**State of Montana's Response to Design Review Team Comments on the
Clark Fork River Operable Unit Phase 7 Preliminary Design and
Design Criteria Memo**

**Presented at the Design Review Team Meeting
April 29, 2024
Deer Lodge, MT**

**Prepared by the Department of Environmental Quality and
the Montana Natural Resource Damage Program**

August 2024

CFR PHASE 7 - Hydraulics Channel - Design 2023 - Upstream Reference Cross Section

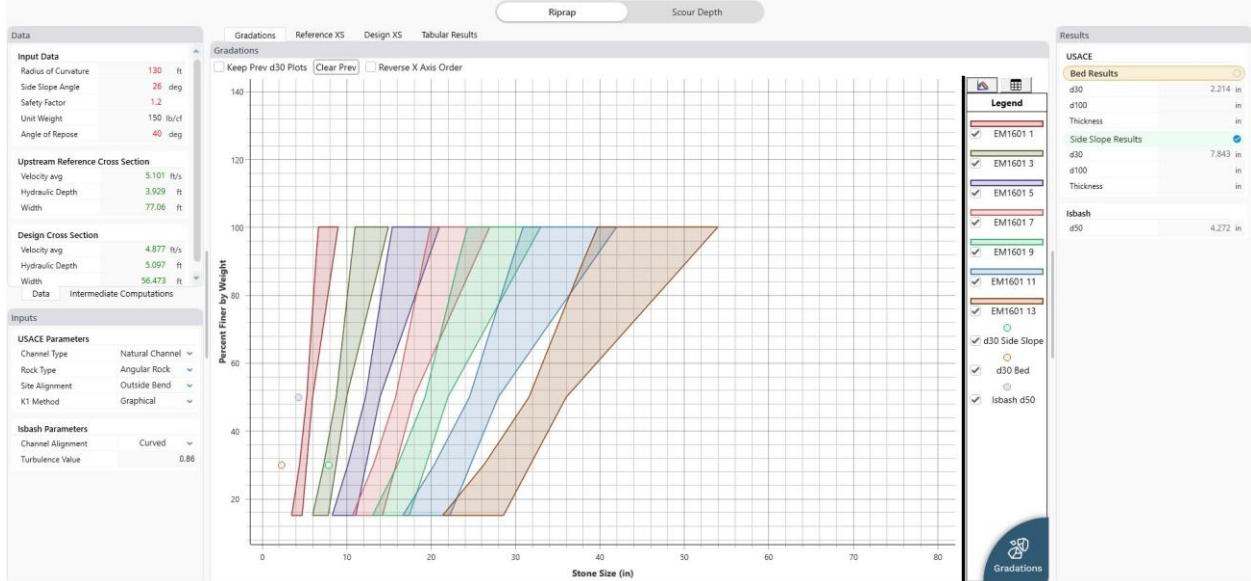
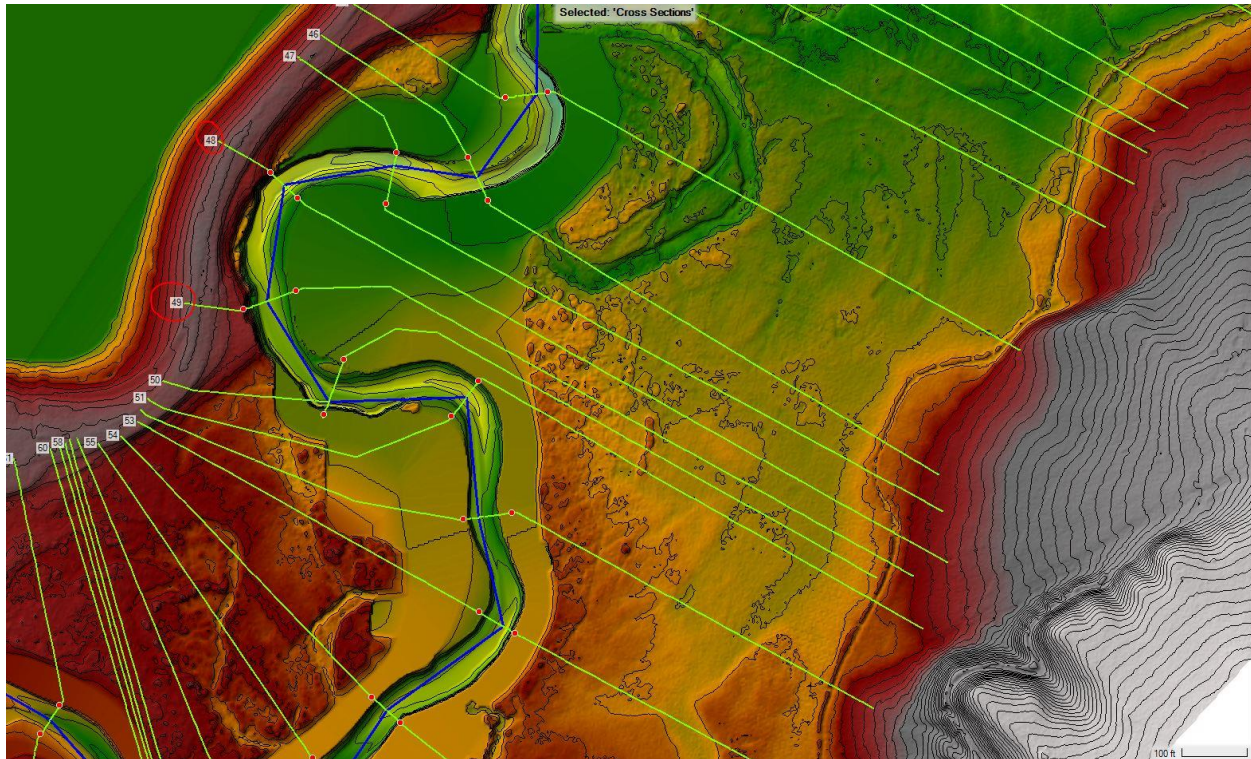
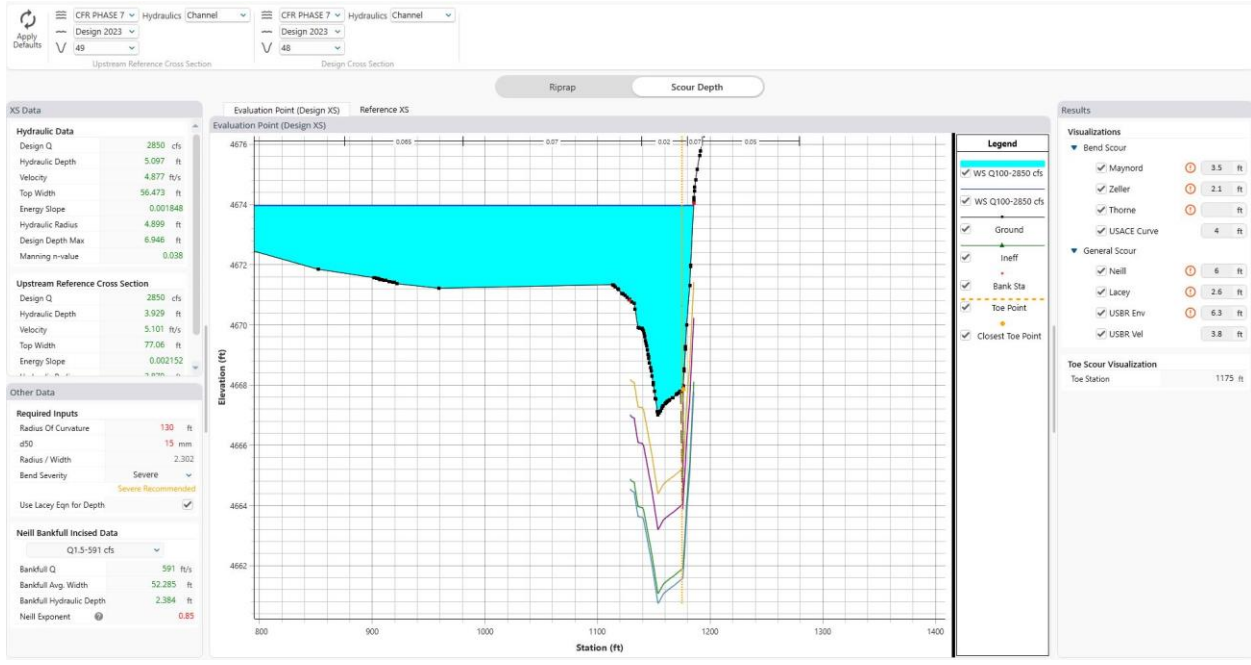
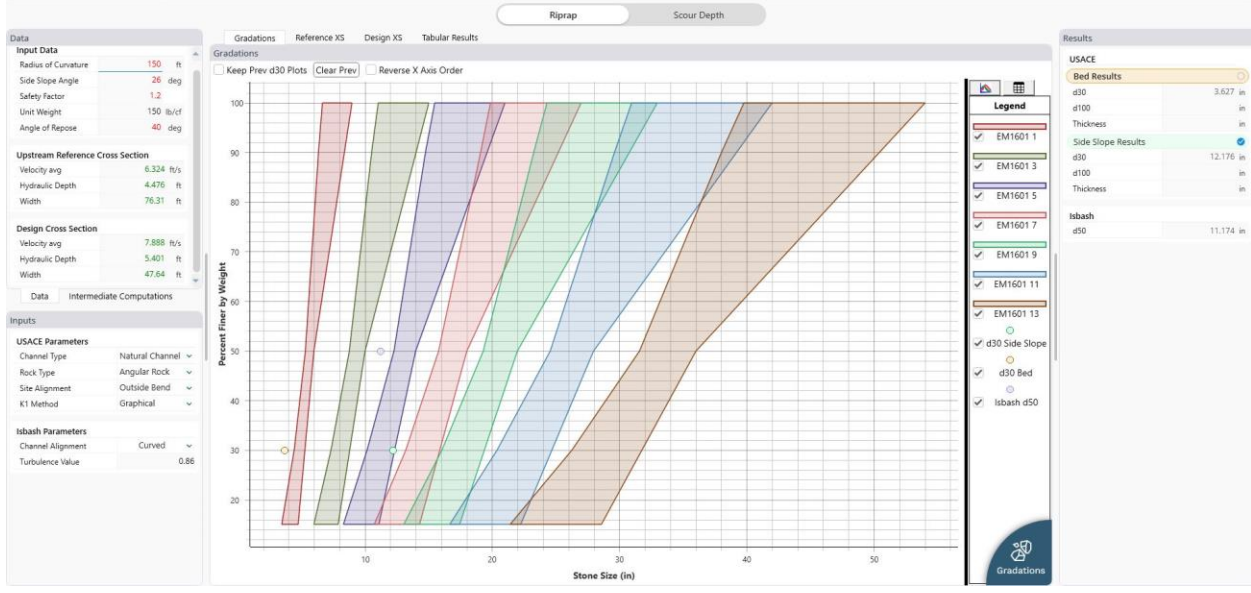
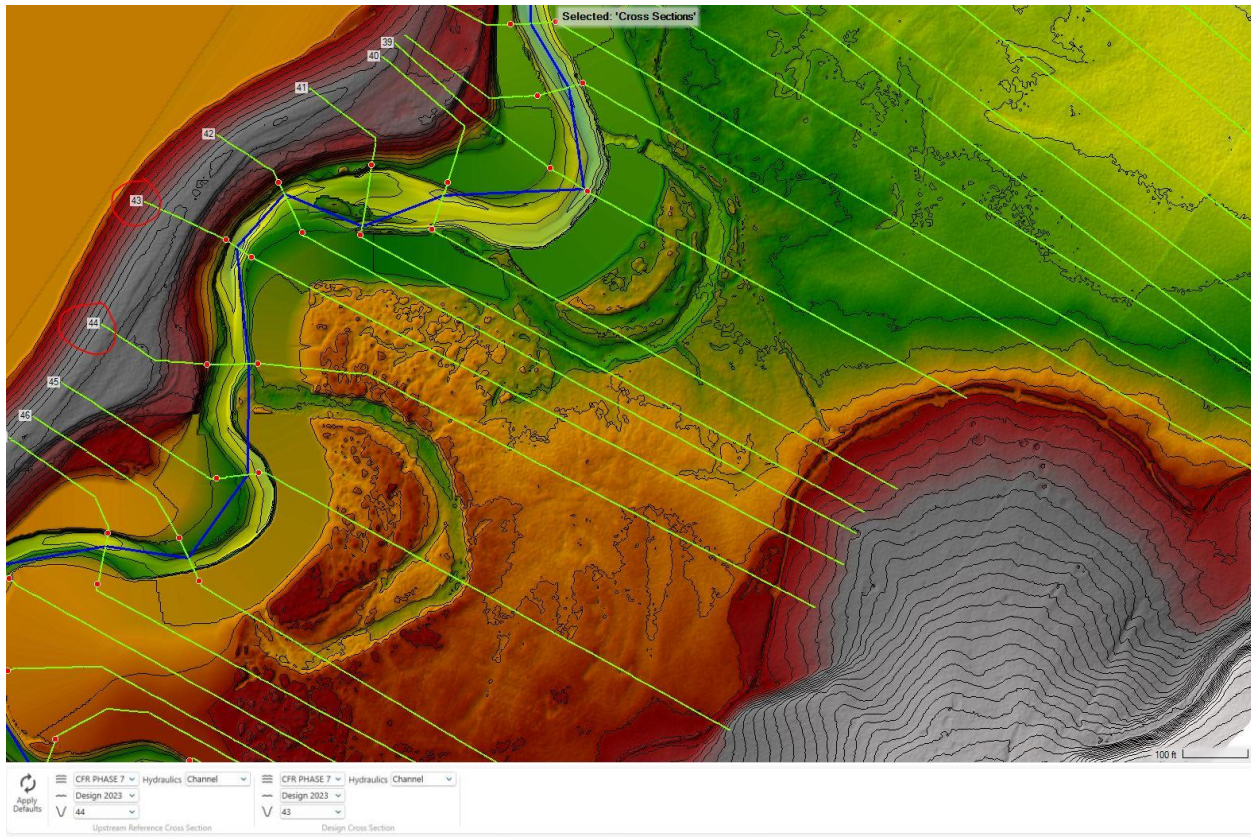
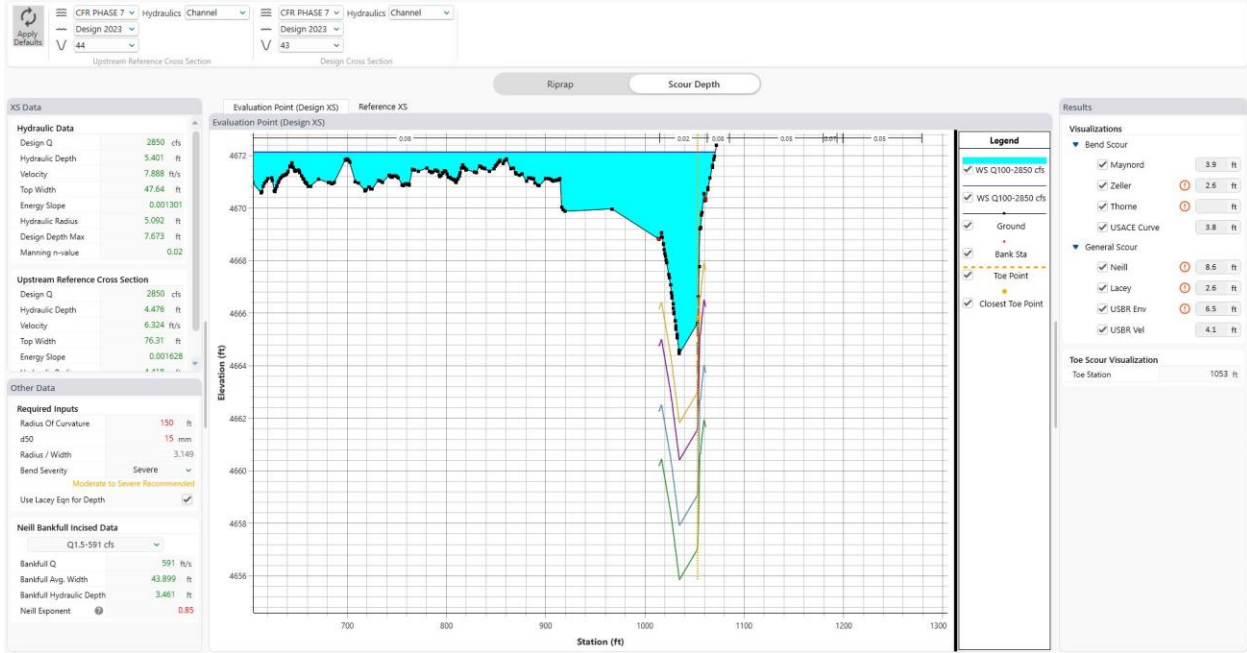
Comment 16: As shown on Design Sheet D103, the rock riprap bank stabilization treatment appears to use a “launchable toe” or ballast. This ballast does not appear to contain the recommended volume of material necessary for this type of application. Please provide calculations based on the USACE EM 1601 used to size the rock and estimate the dimensions for the ballast section.

Response: That is correct. The design detail has been updated to include note about increased riprap thickness at launchable toe to account for rock lost to launching scour. Rock riprap sizing and scour tools from HEC RAS modeling were used to design stabilization and clipped images of the design for each bank section are included below (Figures M).

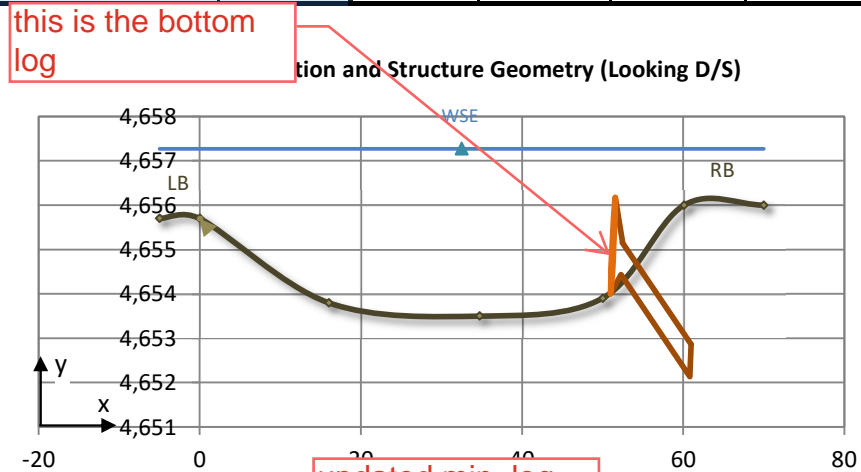
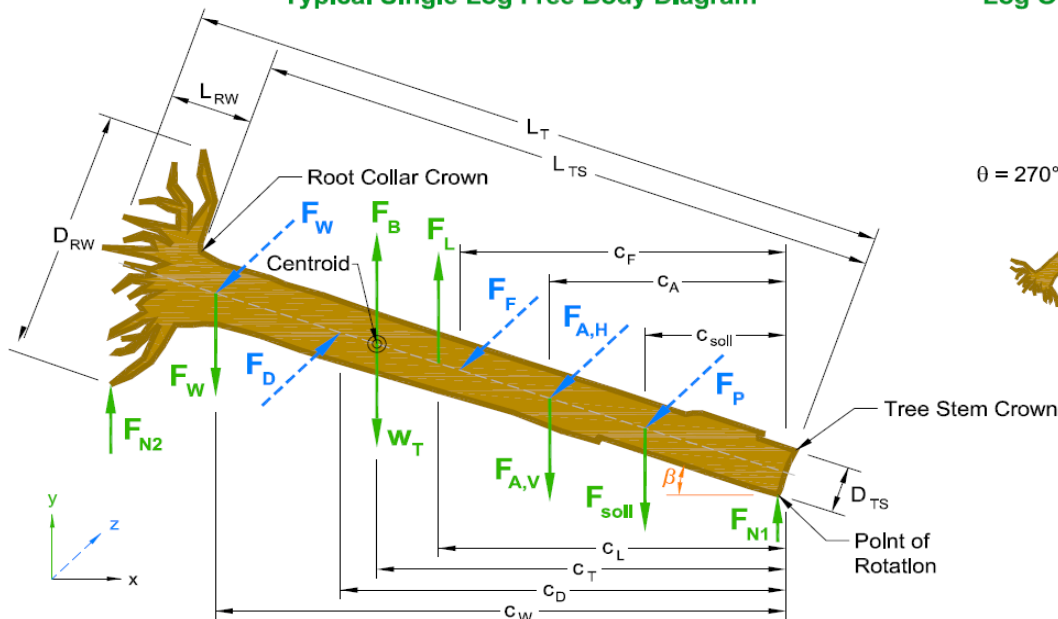
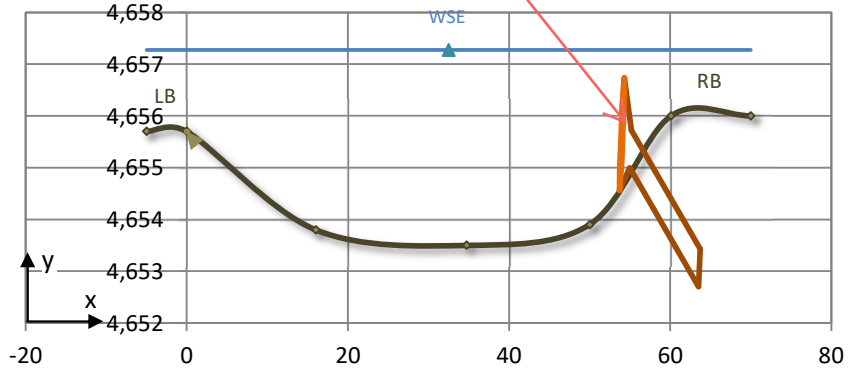
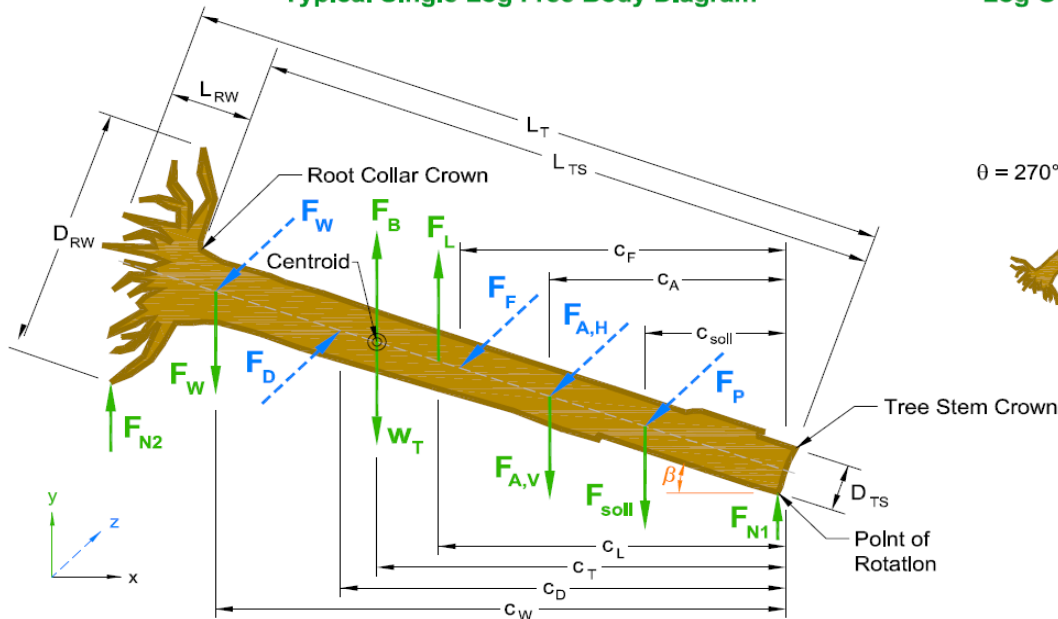
Comment 15: An example of the log stability analysis was to be included in Attachment 7, however, Attachment 7 only contains an example for the Brush Matrix treatment. Please provide a stability analysis for large wood.

Response: A stability analysis for large wood is included in the Appendices.

updated min. log length to provide stability at Q10
